# Petrel Firmware v27 Release Notes

DocRev: A

Date: 2014-11-19

Digital compass view on the Petrel 2

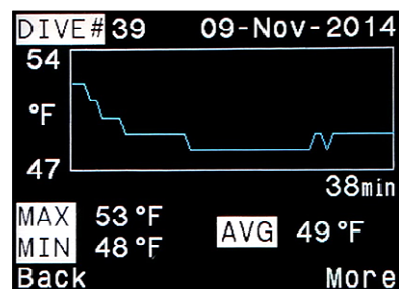
- **NEW FEATURE:** Tilt compensated digital compass. Accessed by pressing the right button once.

Additional dive information can now be viewed in the dive log

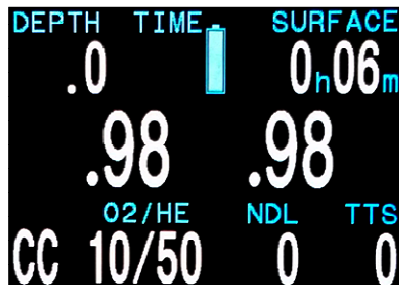
- **NEW FEATURE:** Additional information can now be viewed in the dive log view. Accessed after the temperature graph (see above). Includes:
  - Mode (OC Tec, OC Rec, OC/CC, Gauge, etc)
  - Surface Interval
  - Surface pressure in millibar
  - Deco model and conservatism
  - Start CNS %
  - End CNS %

Two sensors can now be used in the external PPO2 monitoring mode (not available on controller models)

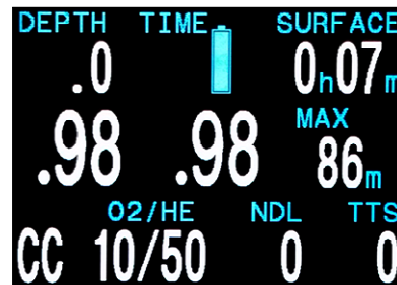
- **NEW FEATURE:** External PPO2 monitoring is now supported for 2 sensors (previously only allowed 1 or 3 sensors). Access the 2 sensor mode by performing a PPO2 calibration with only sensors #1 and #2 connected (single sensor mode accessed by calibrating with only sensor #2 connected). When using the 2 sensor mode, a configurable value may be displayed on the right side of the screen.

A configurable value (maximum depth in the above image) can optionally be displayed
